**NW Natural Pre-Remedial Design Data Gaps Sampling
Gasco Sediments Site – Spring 2020
Field Change Request Form**

Project Name: Gasco Sediments Cleanup Action **Subconsultant:** Anchor QEA, LLC

Field Activity: Subsurface Sediment Sampling **Request Number:** 13

Field Change Request (FCR) Title: Additional Perimeter Subsurface Sediment Core Collection and Analyses to Determine Final Project Area

Figure 1
Proposed Additional Subsurface Sediment Core Locations

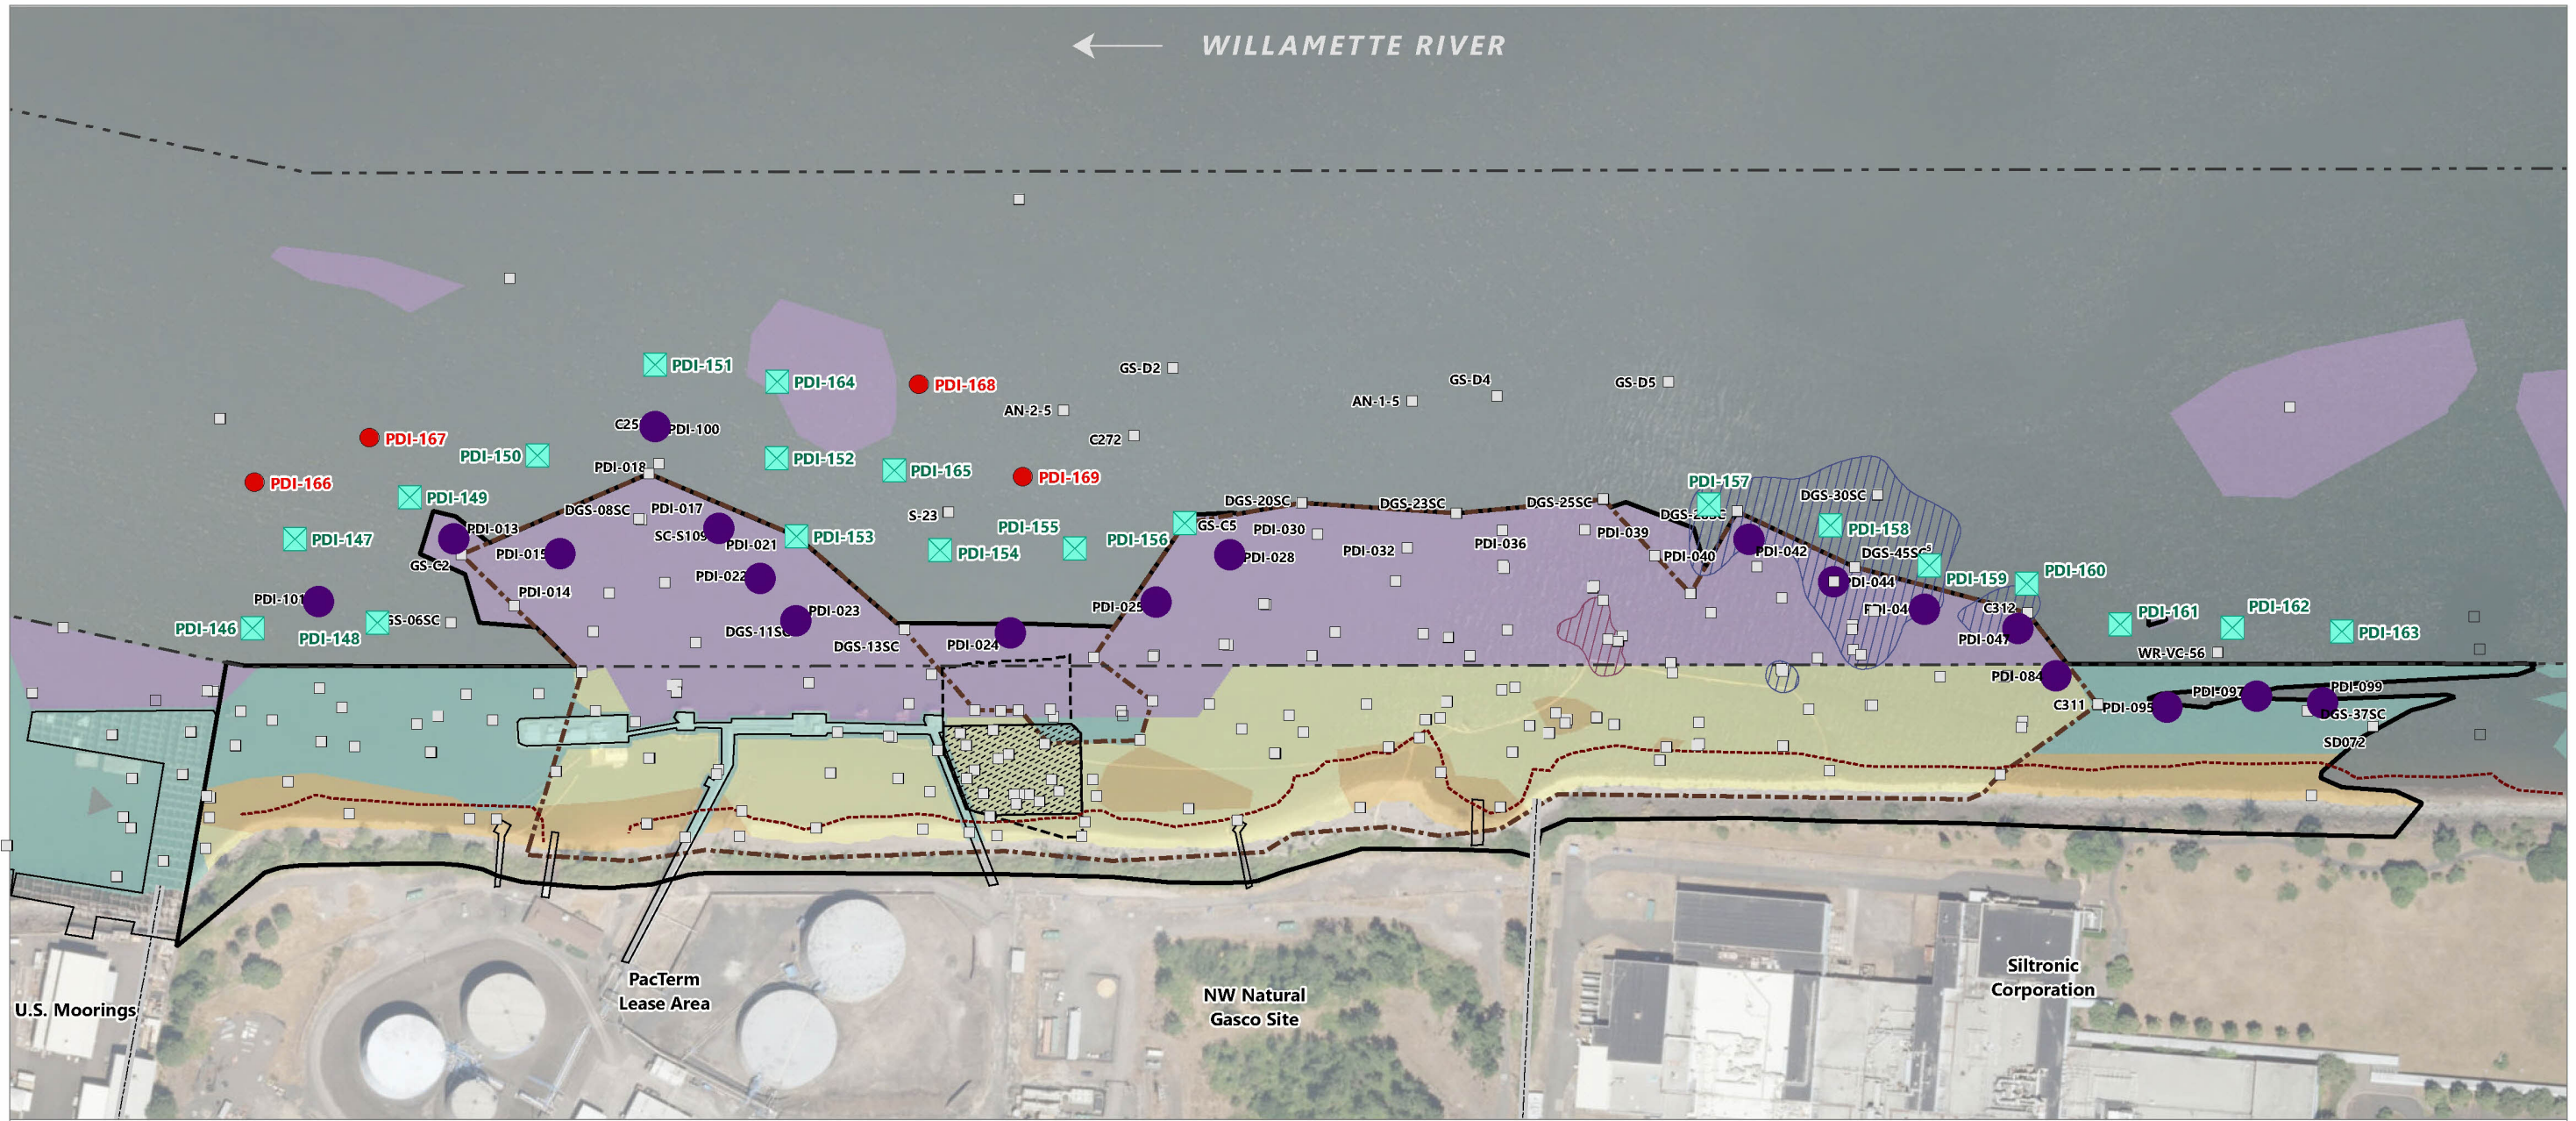
Description
<p>On April 16, 2020, NW Natural received approval from the U.S. Environmental Protection Agency (EPA) on Field Change Request Form No. 10 (FCR 10). FCR 10 described the rationale and approach for the collection of 18 additional perimeter subsurface sediment cores and analyses to determine the Final Project Area. The coring work was started on April 20, 2020, and all of these additional subsurface sediment cores have been successfully collected and processed with preliminary chemistry results received from the analytical laboratory. In addition, preliminary chemistry results have also been received on several cores collected pursuant to the EPA-approved FCR 12 dated April 24, 2020. Preliminary chemistry results from three locations (PDI-147, PDI-149, and PDI-165 [Figure 1]), identified sediment concentrations exceeding the Record of Decision Table 21 total polycyclic aromatic hydrocarbon remedial action levels (RALs). Due to these preliminary chemistry results, and in order to collect all necessary data for remedial design during this mobilization, NW Natural proposes to collect four additional sediment cores to bound potential RAL exceedances.</p>

Recommended Change
<p>NW Natural proposes to collect four additional sediment cores less than 150 feet from PDI-147, PDI-149, and PDI-165 at the stations shown in Figure 1 with the geographic coordinates provided in Table 1. The samples will be collected, processed, and submitted for chemical analysis consistent with FCR 10.</p>
